SUBJECT: Forwards addl info re isolation devices for SPDS, per NRC
 860110 request.

Subject: Palo Verde Nuclear Generating Station (PVNGS)
Units 1, 2 and 3
Docket Nos. STN 50-528 (License NPF-41)
STN 50-529 (License NPF-46)
STN 50-530
Additional Information Concerning Palo Verde
Safety Parameter Display System (SPDS)
File: 86-056-026; J.9.02

ATTACHMENT

FIGURE 1
TYPICAL CHANNEL TEST CONFIGURATION
FOR
CLASS 1E ANALOG ISOLATION AMPLIFIER TEST

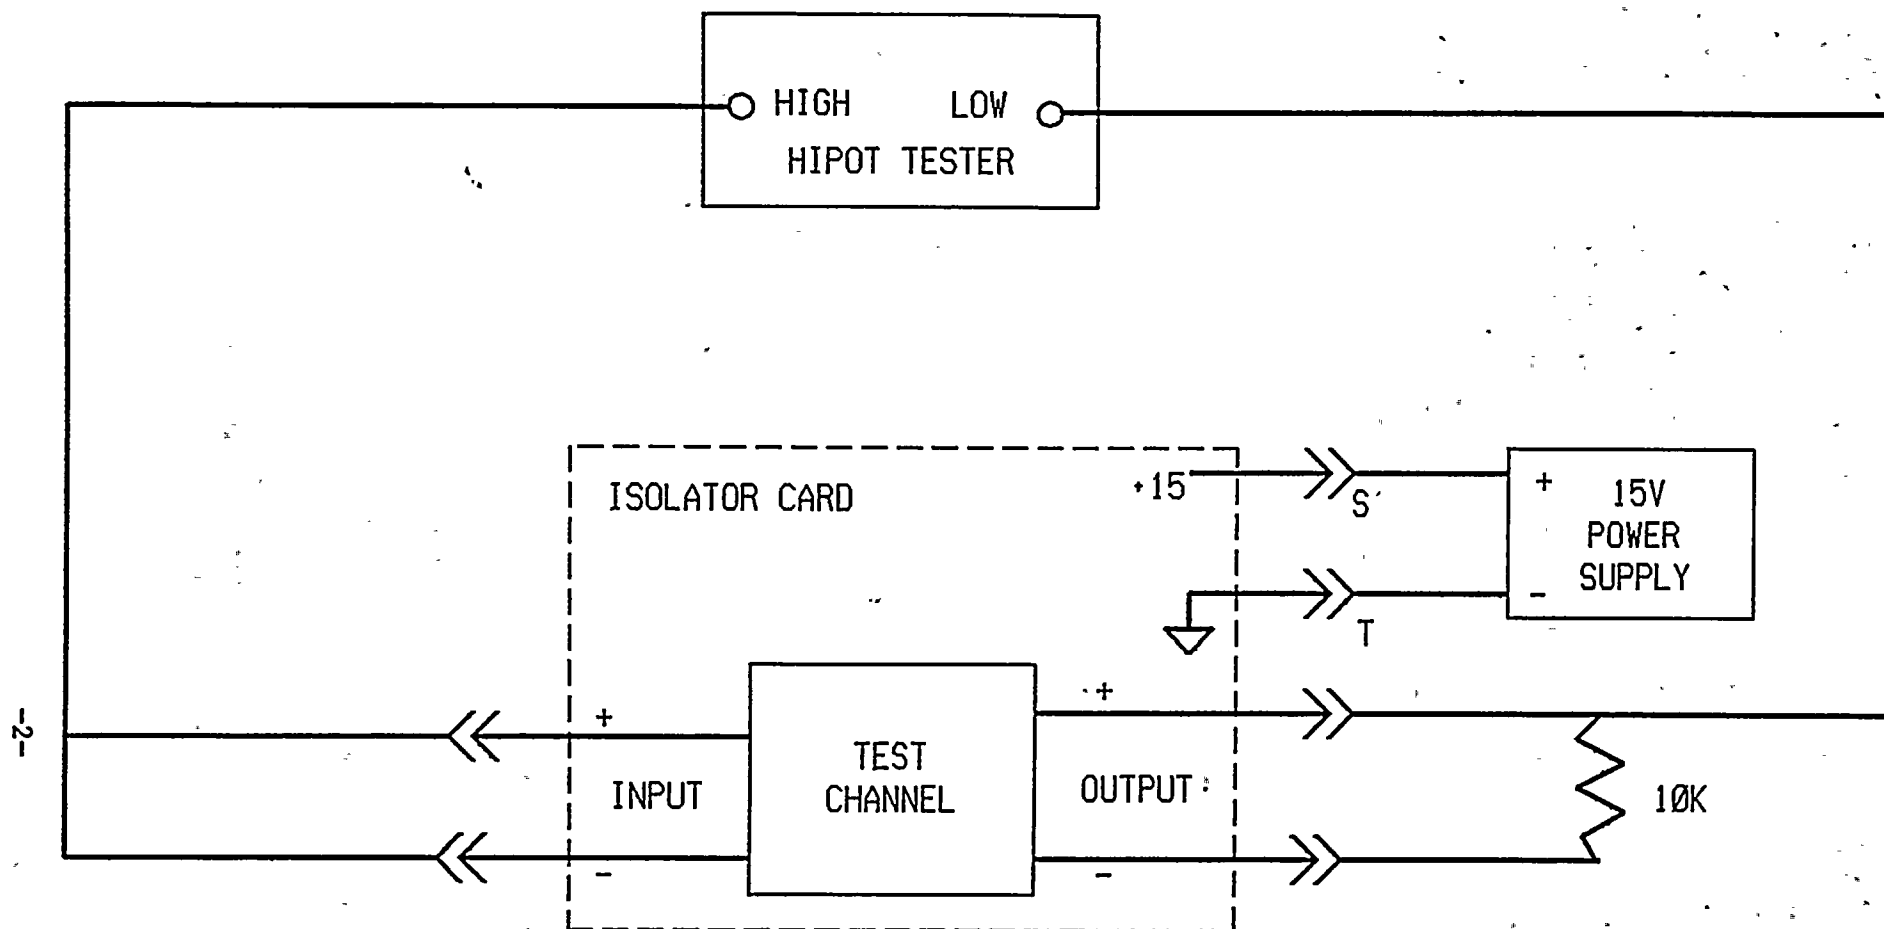
For each type of device used to accomplish electrical isolation describe the specific testing performed to demonstrate that the device is acceptable for its application(s). This description should include elementary diagrams where necessary to indicate the test configuration and how the maximum credible faults were applied to the devices.

To perform the hipot test, the hipot tester and the associated cabling were connected to an individual test channel as shown on Figure 1. Once the test channel was set up, the 15 volt power supply was turned on. The voltage applied to the test channel input was then gradually increased, observing the hipot tester ammeter readings and stopped when 3000 volts was reached or the test channel failed. Zero leakage current across the 1E side and non-1E side at 3000 volts was the criteria for passing the hipot test. These steps were repeated for all 4 channels on all 12 tested cards.
